THE HILLS AT LORSON RANCH

PLANNED UNIT DEVELOPMENT AND SITE PLAN

Engineering Review
07/10/2020 4:03:43 PM
dsdrice
JeffRice@elpasoco.com
(719) 520-7877
EPC Planning & Community Development Department
See comment letter also

LS V_1 redline.pdf Markup Summary

PUD TRACT MAP AND DETAILS

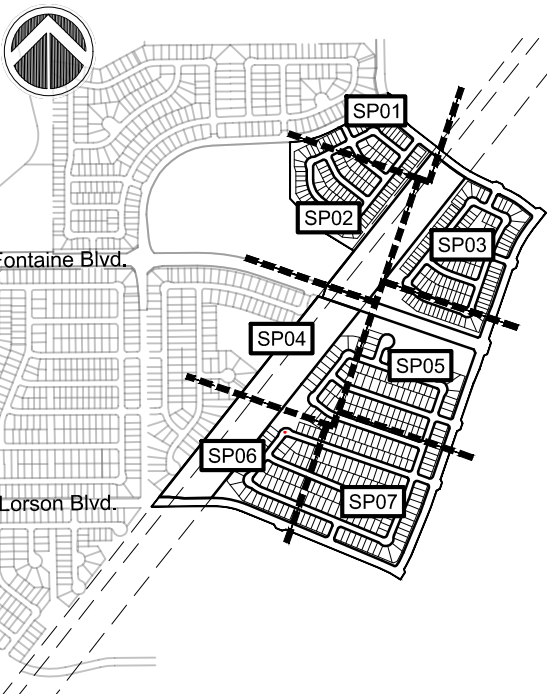
is the MVEA easement in its own tract? who owns and maintains that? is a trail proposed through the tract to connect internal trails? Perhaps should be labeled as undevelopable tract? add acreage.

RESPONSE: REVISED TRACT TABLE FOR BETTER CLARITY. MVE EASEMENT LOCATED IN TRACT K & L. TRAIL CORRIDORS SHOWN ON PUDSP PLANS.

SITE PLAN

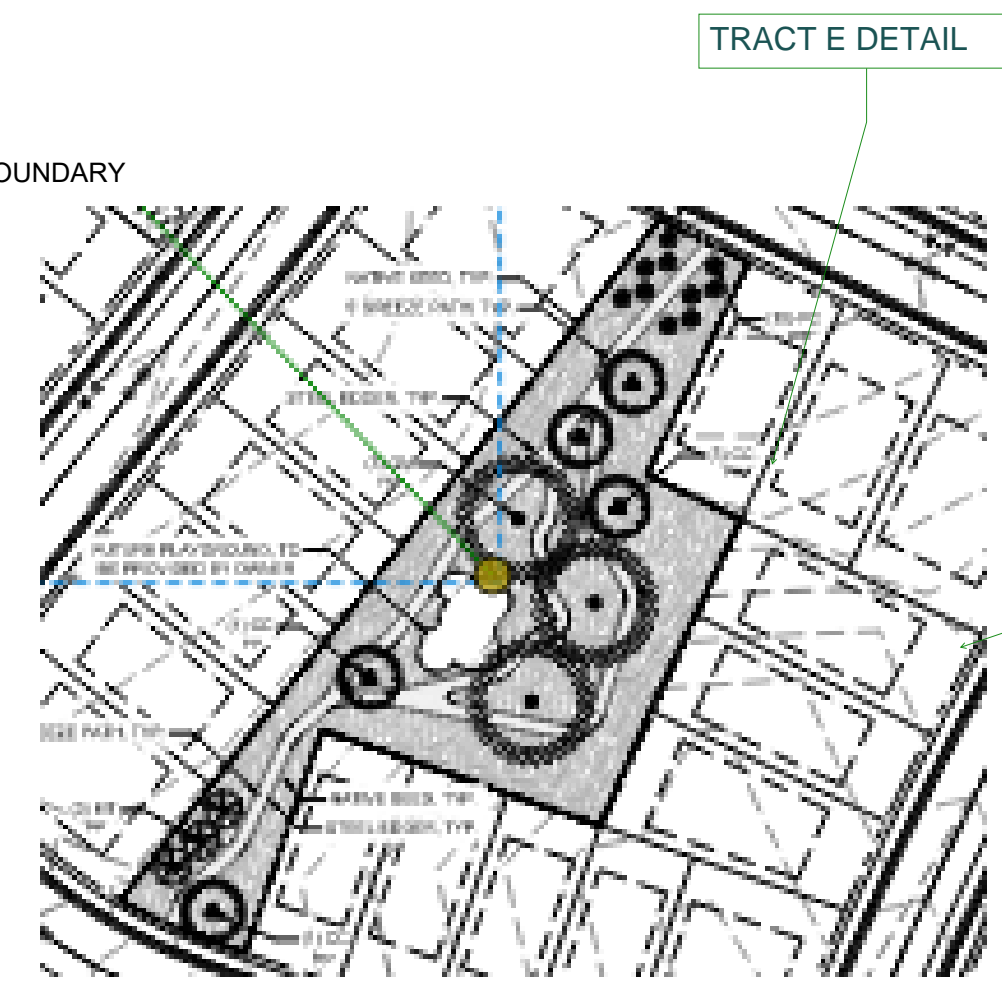
add these little details to significant sheet that have pocket parks to show benefit of the PUDPLAN

RESPONSE: POCKET PARK AREAS WERE NOT ADDED TO THE PUDSP SHEETS FOR CLARITY; HOWEVER THE LANDSCAPE SHEETS WERE ADDED AS PART OF THIS PUDSP ILLUSTRATING THE PARKS.
